### RE: North Bank Resources, Permit No. M-2006-018, Unresolved Problem(s) Noted in a Past Inspection Report

## MINERALS PROGRAM INSPECTION REPORT PHONE: (303) 866-3567

MINE NAME:	MINE/PROSPECTING ID#:	MINERAL:	COUNTY:
North Bank Resources	M-2006-018	Sand and gravel	Garfield
INSPECTION TYPE:	INSPECTOR(S):	INSP. DATE:	INSP. TIME:
Preoperation Inspection	Amy C. Yeldell	September 1, 2016	08:00
OPERATOR:	<b>OPERATOR REPRESENTATIVE:</b>	TYPE OF OPERATION:	
Oldcastle SW Group, Inc. dba United Compar	Jason Burkey	112c - Construction Regular Operation	
County

# PHOTOGRAPHS

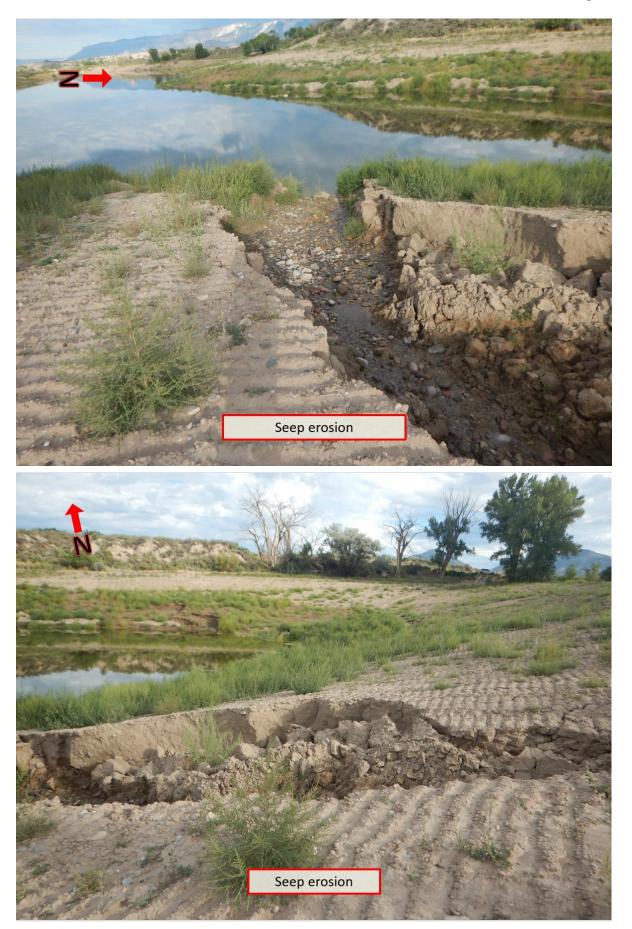
Cell B is mostly reclaimed. The pond's water level is being drawn down slightly. The majority of the slopes have been regraded to a 3:1 slope or less. The operator has made excellent use of tracking to help roughen slopes and prevent riling. There are a few sections where slopes have settled or eroded and will need additional grading. Also approximately 100 linear feet of highwall in the western portion of Cell B required more grading. Topsoil has been replaced throughout cell B. Mr. Burkey was unsure if they were going to seed this fall or allow the ground to settle over the winter and seed in the spring.

Recharge of the pond in cell B was evident. In several areas a water line could be seen on the hillside where soils were saturated. In a few spots underground seeps have eroded the once graded slopes and are now discharging into the lake. Prior to completing final reclamation these areas will need to be fixed. The operator may armor eroded areas where water is discharging to prevent additional erosion and sedimentation. Or in areas where additional water is unlikely grading will be necessary to restore the proper 3:1 sloping.
